**METROPOLITAN DEVELOPMENT COMMISSION  
HEARING EXAMINER**

**Case Number:** 2025-CPL-825 / 2025-CVR-825

**Property Address:** 7140 and 7142 East Washington Street (approximate addresses)

**Staff Reviewer:** Desire Irakoze, Principal Planner II

2025-CVR-825/2025-CPL-825 Updated WaWa Color Site Plan

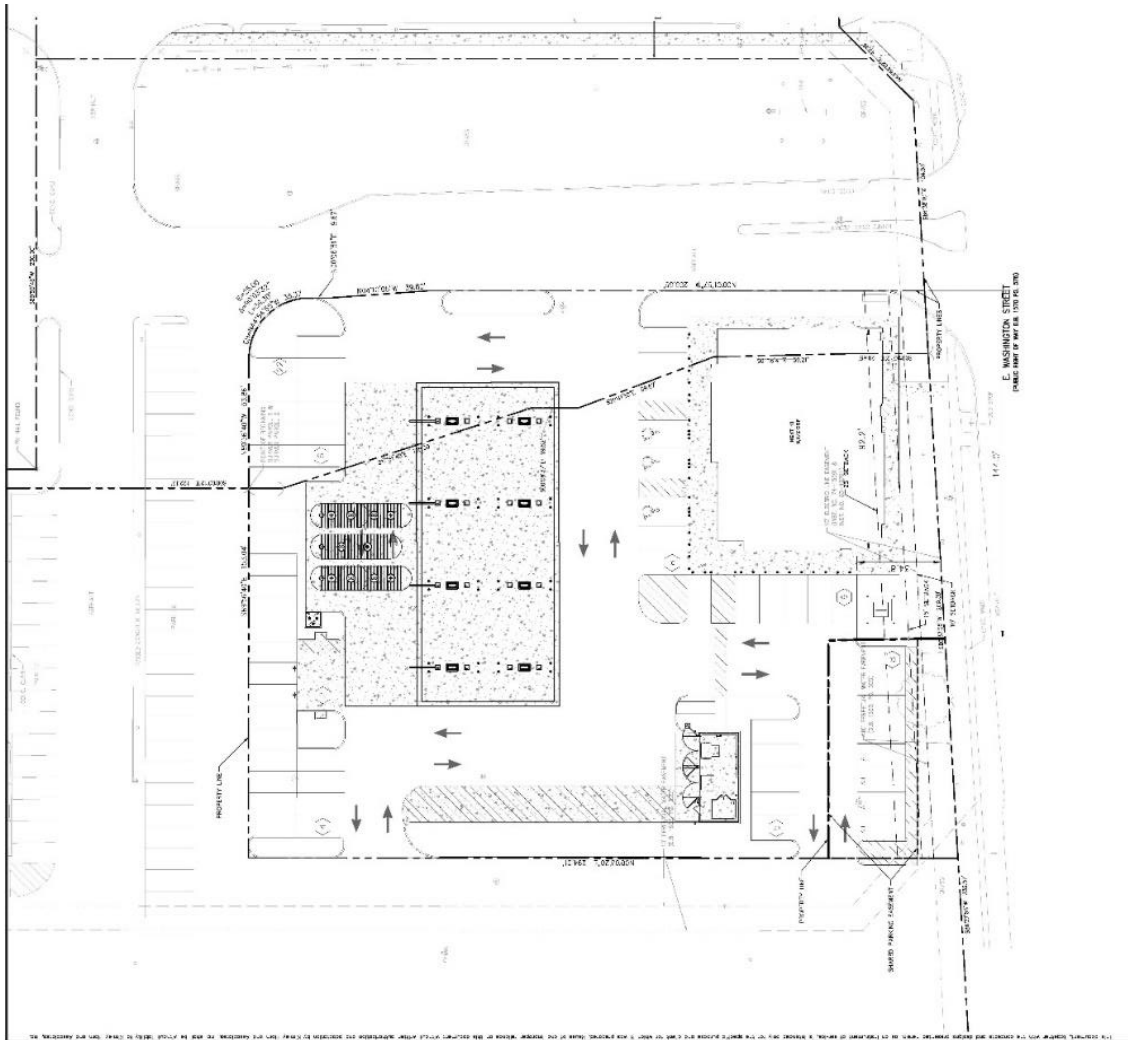
While transparency ratios improved, staff noted that much of the additional glazing is spandrel glass, which is opaque and does not count toward the transparency requirements. Staff recommends a commitment regarding that all glazing materials used meet the definition of transparency as outlined in the Zoning Ordinance.

The updated site plan also remains noncompliant with multiple development standards of the C-4 Zoning District, the Transit Oriented Development (TOD) Overlay, and the Blue Line Transit-Oriented Development Strategic Plan.

The site plan has been updated to show connections to from the building rest of the integrated commercial center.

- The site plan shows a reduction in the number of pump islands/service areas and associated landscaping, from 16 to 12. However, this remains in excess of the eight (8) pump islands permitted under the Transit Oriented Development (TOD) Overlay regulations.
- The petitioner has withdrawn the variance request related to the Front Building line encompassing 37.1 percent of the lot width (where 60 percent is required).

The petitioner originally proposed 16 islands and, following staff feedback, reduced the request to 12. However, this remains non-compliant with TOD regulations. Staff finds that there is no demonstrated hardship or site condition necessitating the additional islands.

The petitioner is seeking relief from the requirement that surface parking areas be located entirely behind the front building line (FBL), with a minimum 25-foot setback from Washington Street. The submitted site plan depicts a parking area encroaching into the required setback, with certain parking spaces located within the front yard.

According to Table 744-402-1 of the zoning ordinance, the proposed 6,372 square-foot fueling station requires a minimum of 26 off-street parking spaces. The petitioner, however, is providing 62 spaces—more than double the required minimum. Staff finds that this surplus of parking indicates there is no true

hardship necessitating the placement of parking within the front yard setback. By simply relocating the eight (8) electric vehicle (EV) charging spaces and two (2) regular spaces currently situated in the setback area to the rear of the site, the petitioner could maintain compliance with parking count requirements while adhering to the TOD Overlay's form-based development standards.

This variance pertains to the TOD Overlay's limitation that surface parking areas behind the front building line may not occupy more than 40 percent of the lot's width. The petitioner's proposed site plan indicates a parking width of 88.1 percent, more than double the allowable maximum.

Staff's analysis indicates that this excessive parking width is a direct result of the lot's oversized frontage dimensions and the building's relatively narrow footprint. Specifically, the subject lot has a width of 209 feet, while the proposed building has a length of only 92.2 feet. According to the standards, a compliant lot would be no wider than 154 feet for the proposed building length.

Therefore, staff recommends **denial** of this variance request and advises the petitioner to further revise the site plan to comply with the permitted number of pump islands

Staff, therefore, **recommends denial** of this variance request as the petitioner has clear and reasonable options for compliance without undue hardship.

Staff therefore **recommends denial** of this variance request and encourages the petitioner to adjust the lot configuration and building footprint accordingly.

2025-CVR-825/ 2025-CPL-825 Updated Elevations

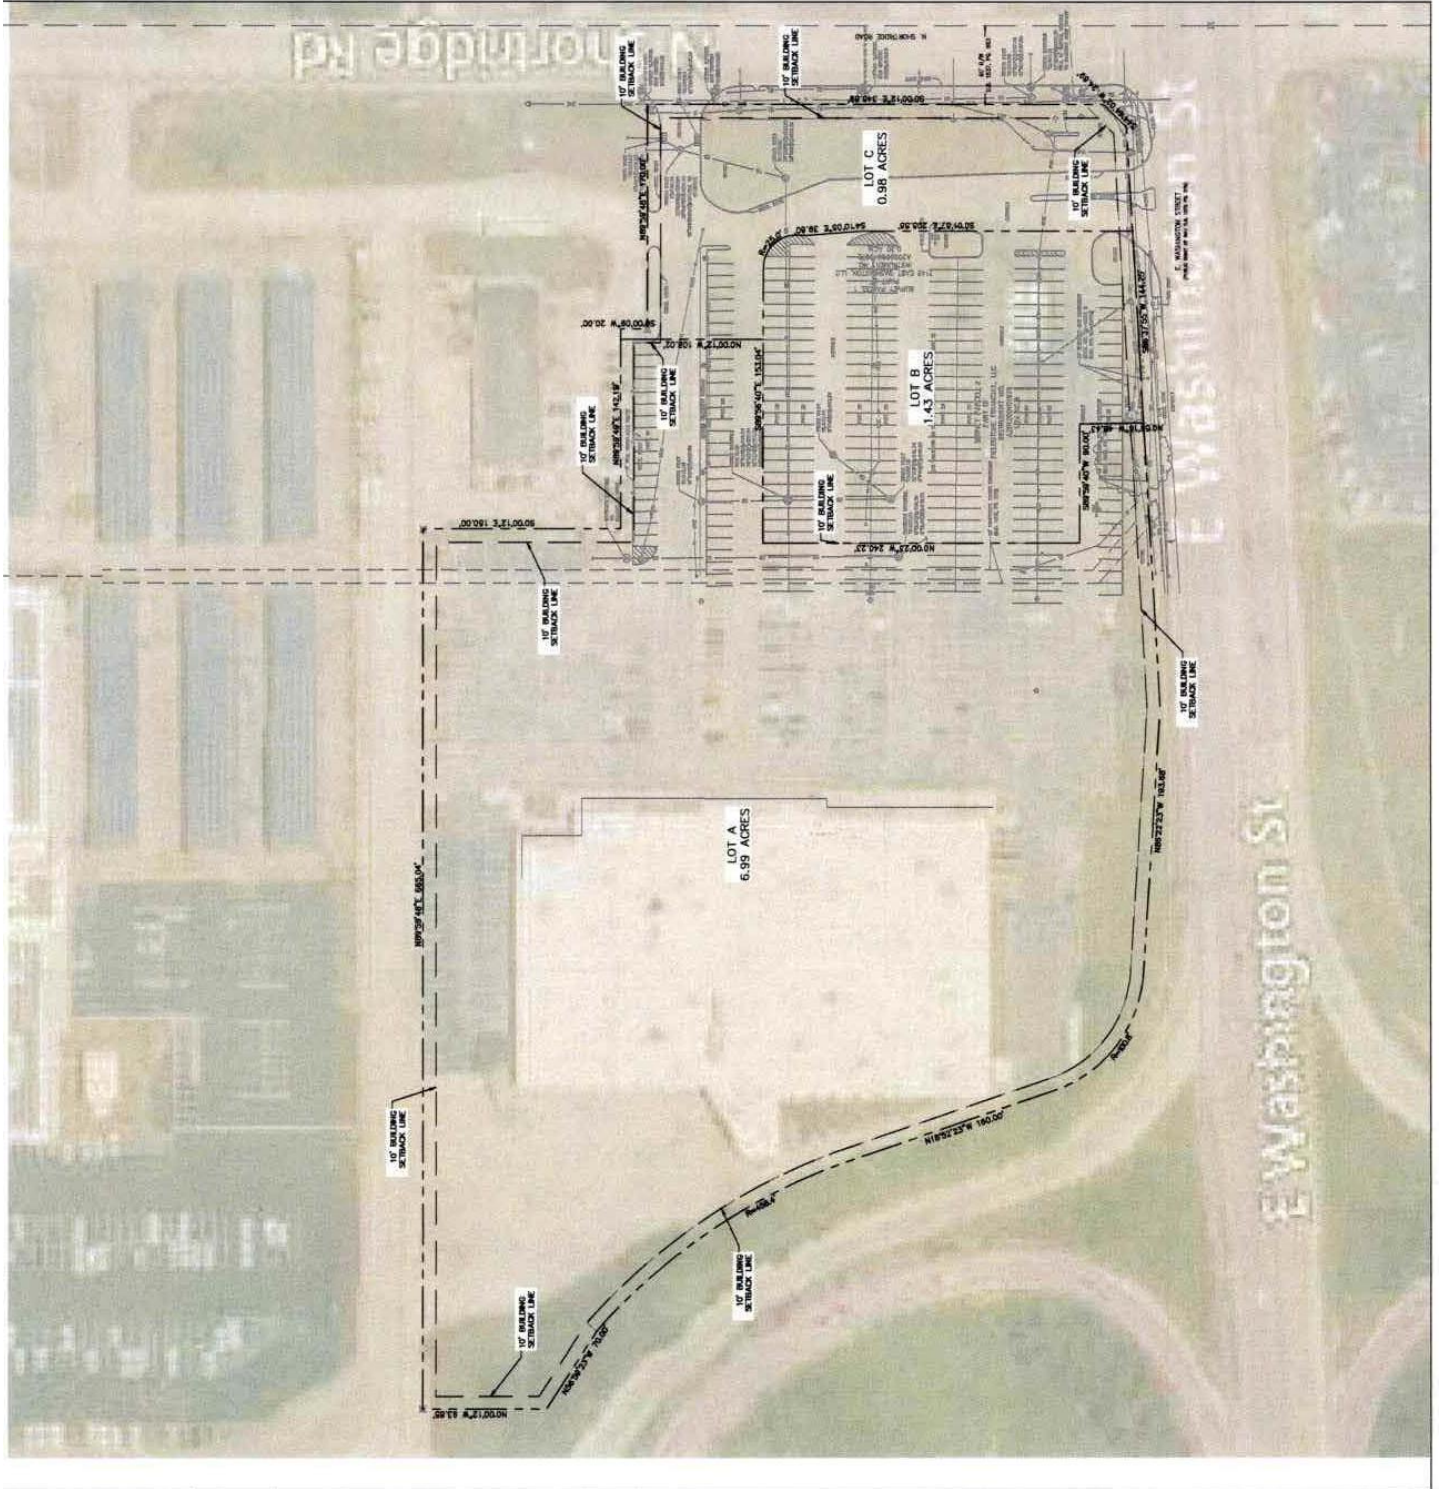
The Hearing Examiner continued these petitions from the July 24, 2025 hearing to the August 14, 2025 Hearing at the joint request of staff and the petitioner's representative to allow additional discussion and submission of updated materials for further discussions. On July 28, 2025, the petitioner provided revised building elevations indicating increase glazing area.

The submitted building elevations indicate substantial non-compliance. The proposed design provides transparency ratios as low as 0 percent (right elevation) and 8 percent (rear elevation), with the front elevation providing only 25 percent transparent glazing—far below the required minimum. Furthermore, much of the glazing depicted on the elevations is spandrel glass, which does not meet transparency standards as it is opaque and does not allow visibility into or out of the building.

The petitioner has offered no compelling justification for retaining such a low level of transparency, and staff finds that allowing this variance would directly contradict the TOD Overlay's pedestrian-oriented design objectives. Accordingly, staff **recommends denial** of this variance request and advises the petitioner to revise the building elevations to meet the transparency requirements outlined in both the TOD Overlay and the C-4 district standards.

2025-CVR-825/ 2025-CPL-825 PLAT

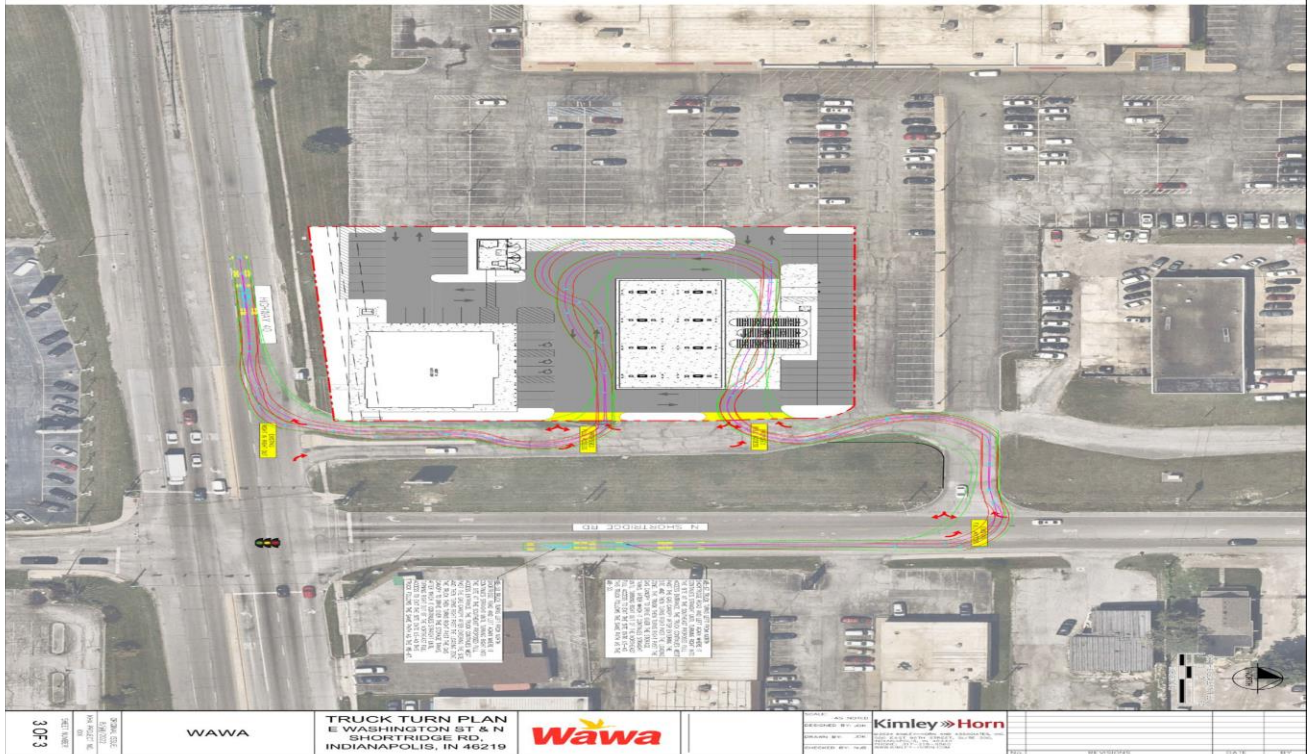
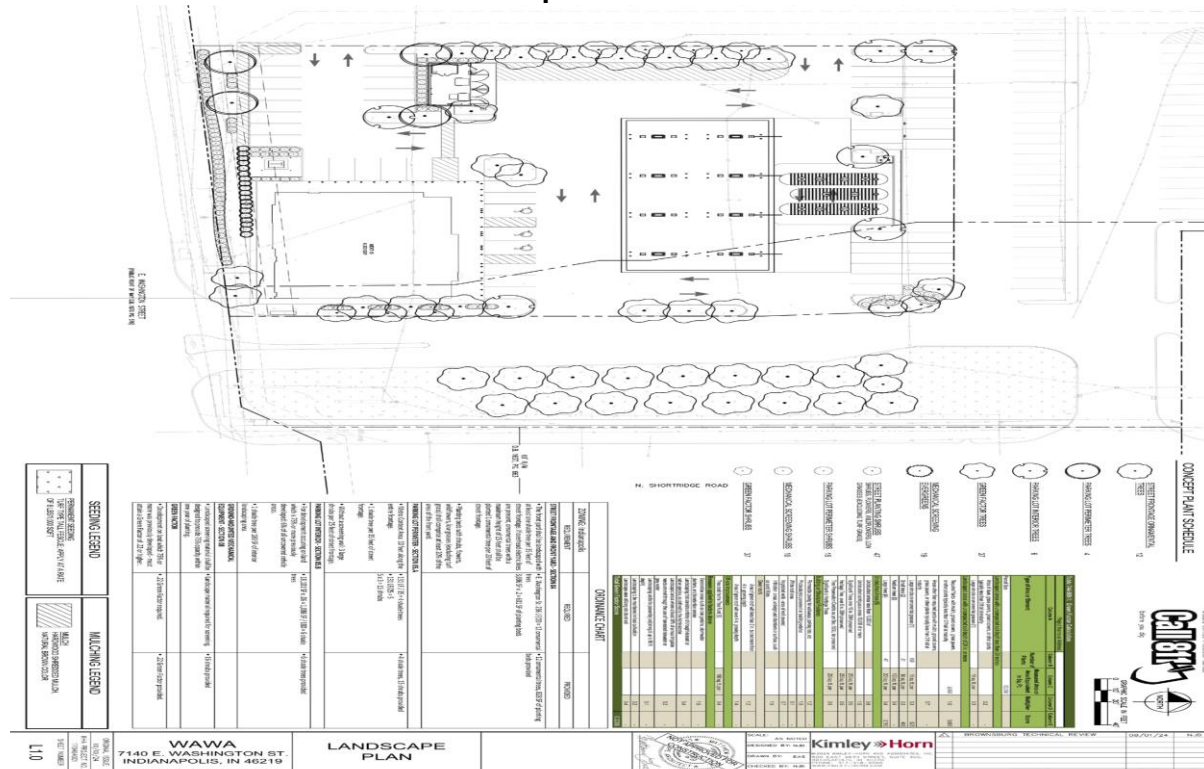
While the configuration appears to be crafted to technically avoid certain variance triggers, most notably the Front Building Line width requirement, it does so through the introduction of a shared parking easement. This easement appears to serve no functional shared purpose and instead functions primarily to reduce the frontage calculation of Lot 1. Staff does not support this approach, as it undermines the intent of the TOD Overlay's frontage requirements and circumvents the established form-based development expectations. A design that complies with the spirit and letter of the ordinance—rather than one that relies on artificial lot divisions—is strongly preferred

Sidewalks currently exist along the East Washington Street frontage. However, per Section 722-301. F.2 of the Ordinance, nonresidential and mixed-use developments with more than one (1) primary building must include an unobstructed walkway at least five (5) feet wide connecting those buildings. The current plan does not provide a pedestrian connection between the buildings on Lot 1 and Lot 2.
